## **STEPHANIE AND LAWRENCE ESTATES SUBDIVISION**

Engineering Comments: FINAL PLAT COMMENTS (should be addressed prior to submitting the FINAL PLAT for review and/or signature by the City Engineer):

APPLICATION NUMBER 4 DATE March 17, 2022

# DETAIL SITE PLAN

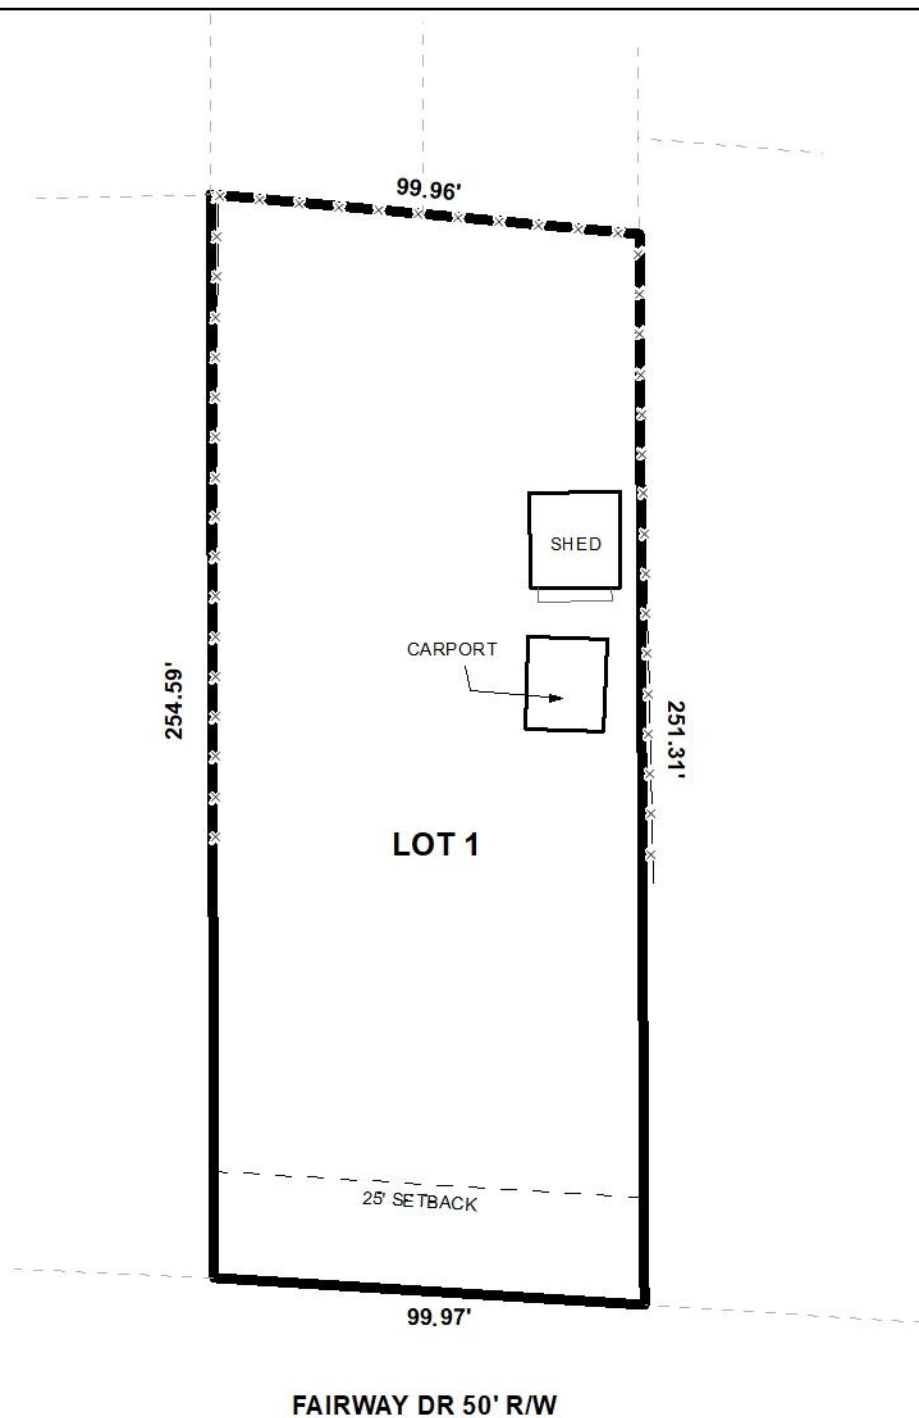
The lot has frontage along Fairway Drive, a minor street without curb and gutter requiring a 60-foot right-of-way. The preliminary plat illustrates a 50-foot right-of-way, thus dedication sufficient to provide 30 feet from the centerline of Fairway Drive should be required, in compliance with Section V.B.14 of the Subdivision Regulations. It should be noted that the Planning Commission has required dedication for other subdivisions along Fairway Drive.

The 25-foot minimum building setback line is illustrated along Fairway Drive, per Section V.D.9. of the Subdivision Regulations, and should be retained on the Final Plat, if approved, adjusted for any required dedication.

Finally, it should be noted that the site was previously developed with a single-family dwelling and two (2) accessory structures. The dwelling was recently demolished, but the accessory structures remain according to the preliminary plat survey. The Zoning Ordinance does not allow accessory structures on a lot without a principal structure (i.e. the single-family dwelling). It should be noted, however, that the property owner has applied for a building permit to construct a new dwelling; therefore, the applicant should either obtain demolition permits for the accessory structures, or submit a letter with the Final Plat stating that the building permits for the new dwelling will be obtained within 30 days of the plat being recorded in Mobile County Probate Court.

- 1) Revision of the plat to illustrate dedication sufficient to provide 30 feet from the centerline of Fairway Drive;
- 2) Retention of the lot's size in acres and square feet on the Final Plat, or provision of a table on the Final Plat providing the same information, adjusted for dedication;

- 3) Retention of the 25-foot minimum building setback line along Fairway Drive, in compliance with Section V.D.9. of the Subdivision Regulations, adjusted for dedication;

- 4) Obtainment of either demolition permits for the accessory structures, or submit a letter stating that Building Permits will be obtained within 30 days of the plat being recorded in Mobile County Probate Court, prior to signing of the Final Plat;
